1940 BAY DRIVE

FINAL SUBMITTAL
11/05/2023

DRB File No. 23-0934

Date: 11/05/2023
Scale: AS SHOWN
Project No.: 2133
Sheet Name: RESPONSES TO COMMENTS
Sheet No.: **A-000**

1
A-003.3
demolition plan
SCALE: 1/8" = 1'-0"

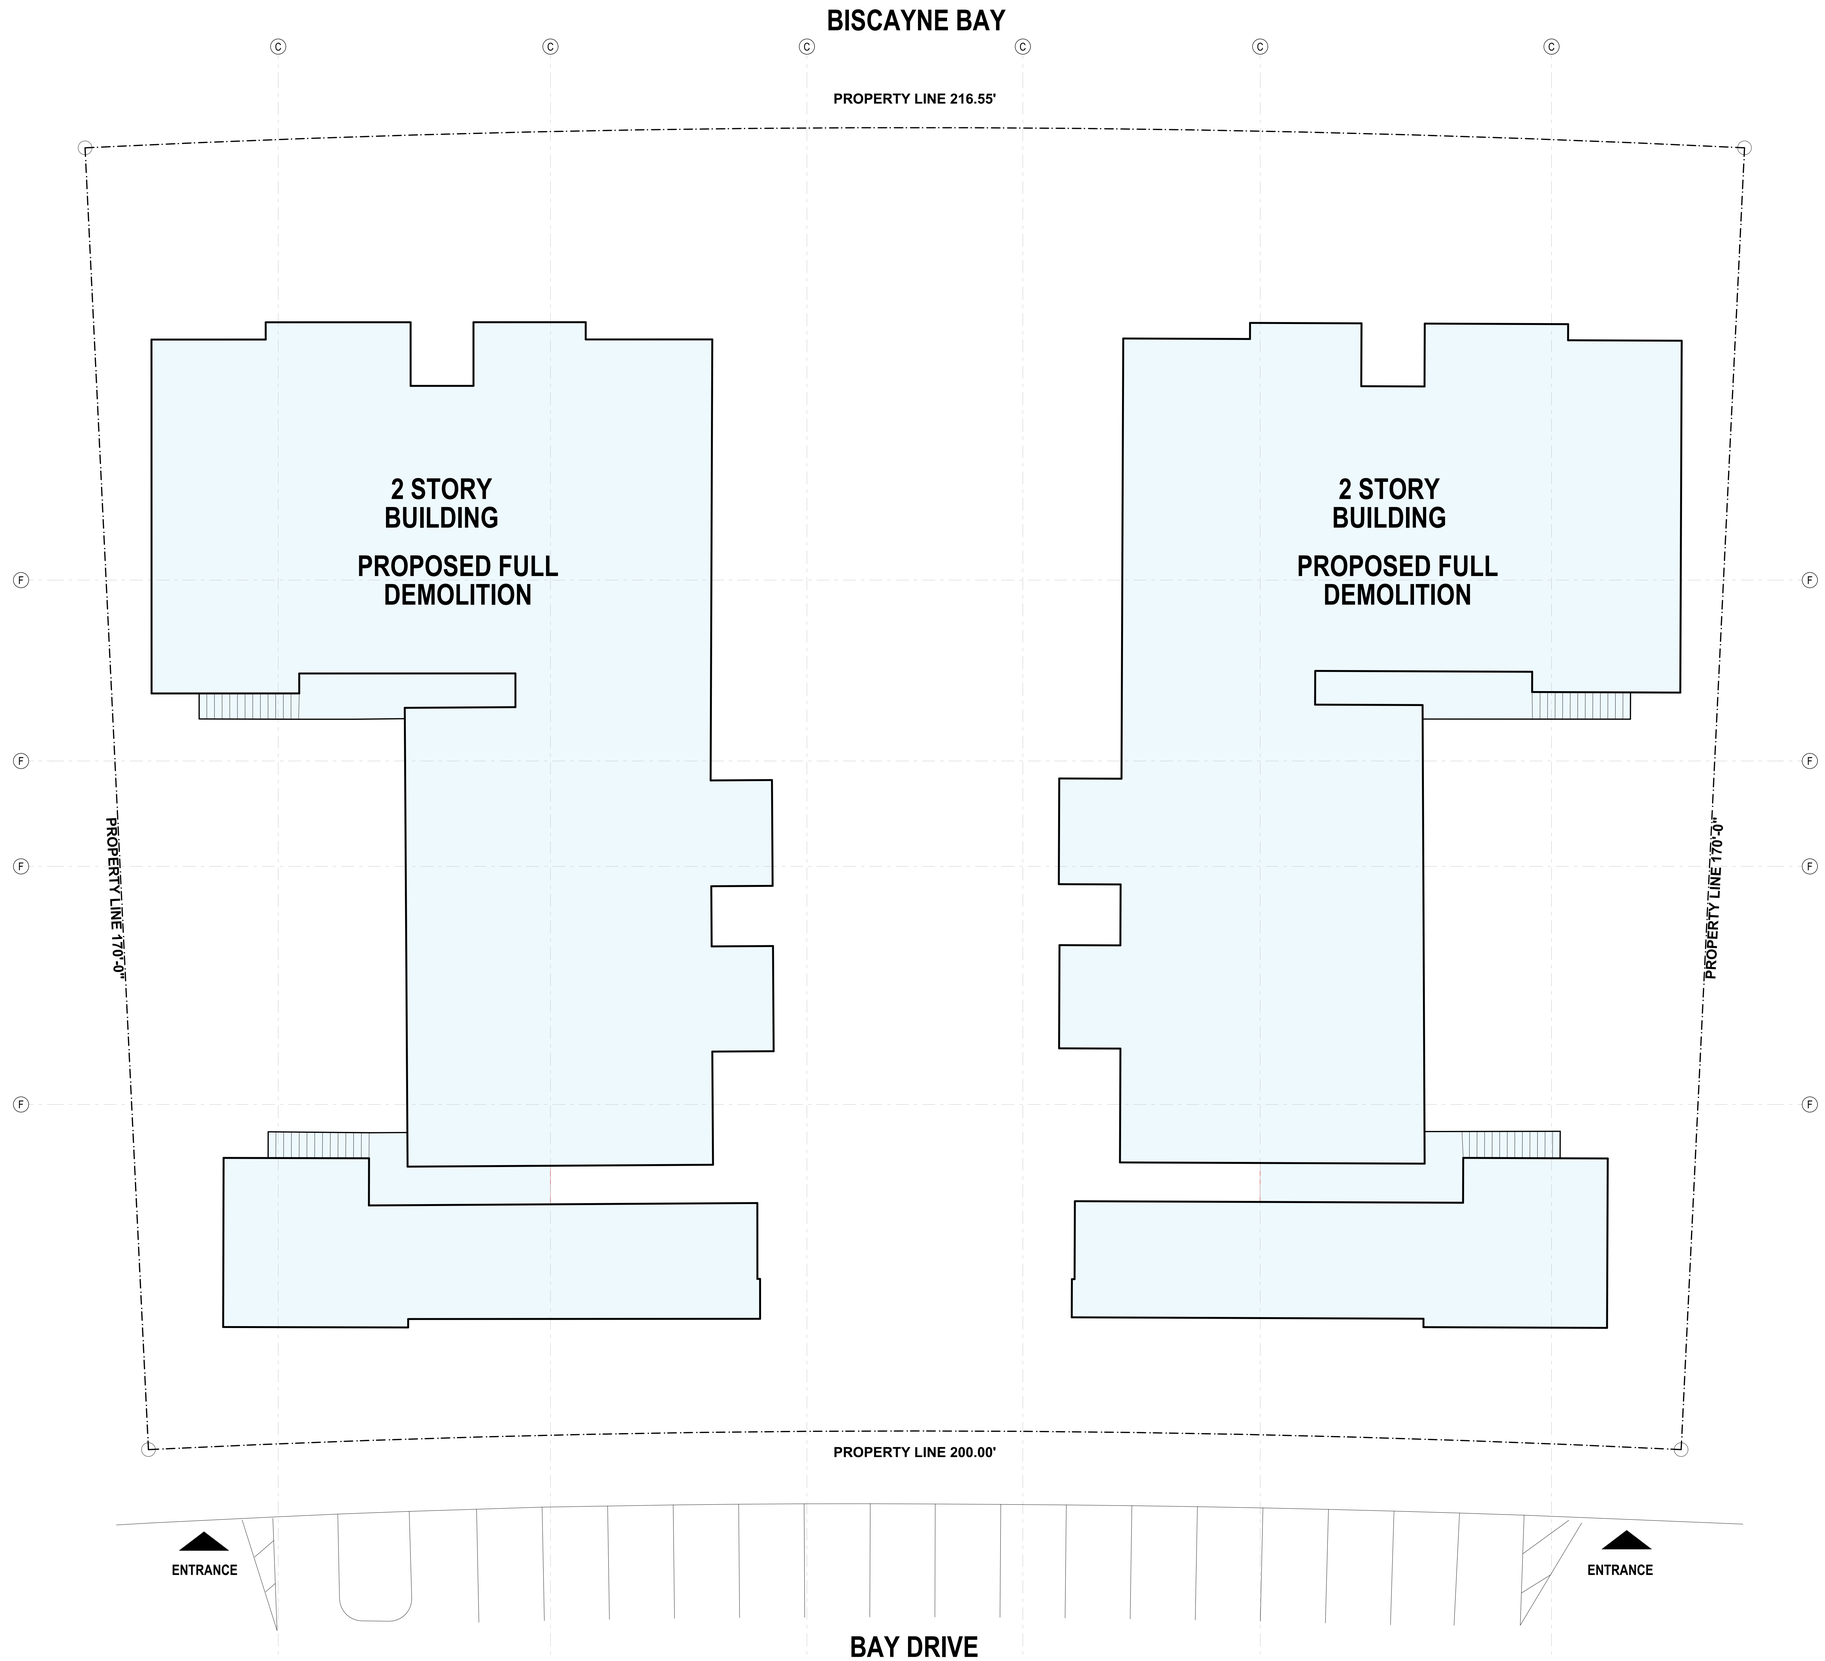
2. DRB PLAN REVIEW - Planning Department - First Submittal Comments					
	1		APPLICATION COMPLETENESS		
2		a.	Provide a copy of all current or previously active Business Tax Receipt.		
3		b.	The survey provided shall include the lot area and grade elevation. Grade is defined as the elevation measured from the centerline of the sidewalk. If no sidewalk is present, grade will be taken from the crown of road. Additionally, the survey shall be sealed by the licensed surveyor	See updated survey	A-000
4		c.	A copy of the survey shall be included in the architectural plan package.	A-000 SURVEY added.	A-000
5		d.	Include current color photographs, dated, minimum 4"x6", of project site and existing structure (No Google images).	A-003.2 PHOTOGRAPHIS OF EXISTING ON SITE STRUCTURE ADDED.	A-003.2
6		e.	Demolition Plans (Floor Plans & Elevations with dimensions) shall be submitted.	A-003.3 DEMOLITION PLAN ADDED. Proposed full demolition of all structures on site.	A-003.3
